Appeal of Planning Commission Resolution No. 26-05 Regarding Coastal Development Permit No. 19-012 (25200 Pacific Coast Highway, APNs 4459-013-021 and 4459-014-018; Owner, PAR PCH, LLC; Appellant, Jun Hall for Concerned Citizens of Malibu Road, Inc.)

Amended[1] Malibu City Council
Special Meeting Agenda

Wednesday, August 19, 2026

Pile Base Elevation vs Slide Base Elevation

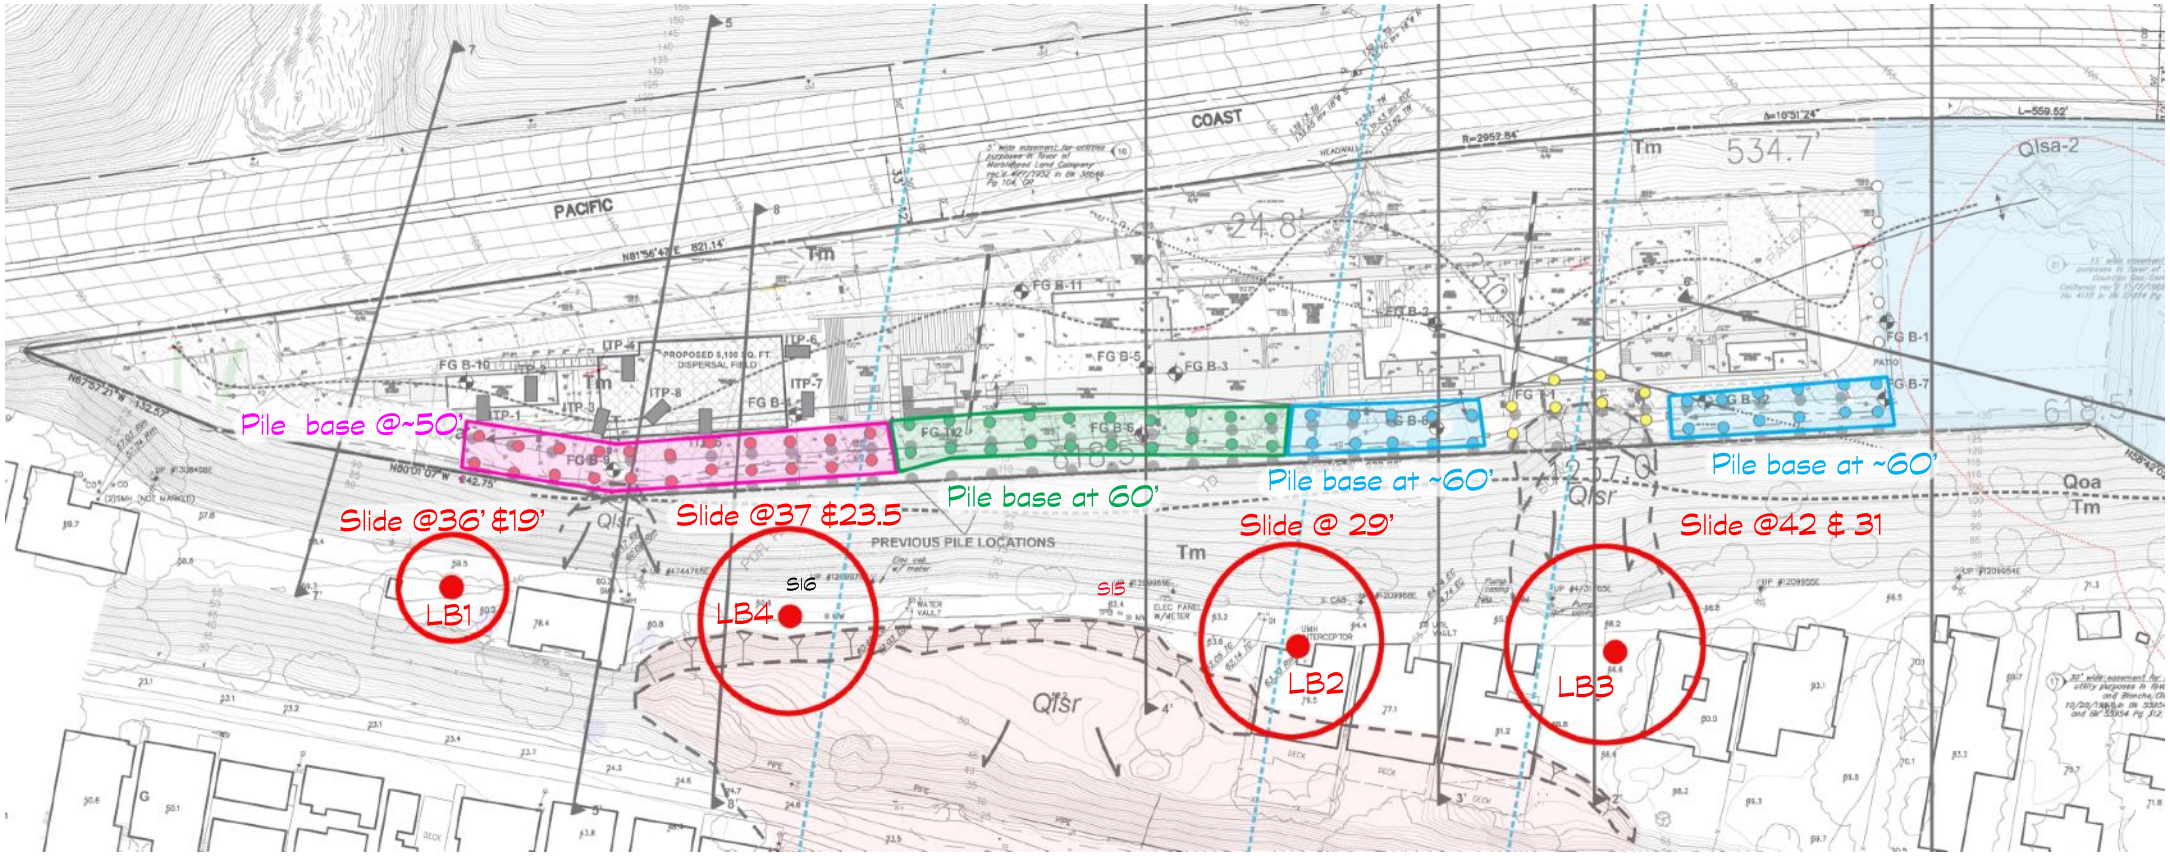
Table of pile depth vs. slide depth

Pile color from map	Red	Green	Blue and Yellow
Depth/pile length	50’	60’	60’
Bottom elevation of pile	50’	60’	60’
Slide Plane Elevation	36’& 19’/37’23.5	37’-29’	29’-31’
Deficit	14’ to 31’	36.5’-31’	31’-29’
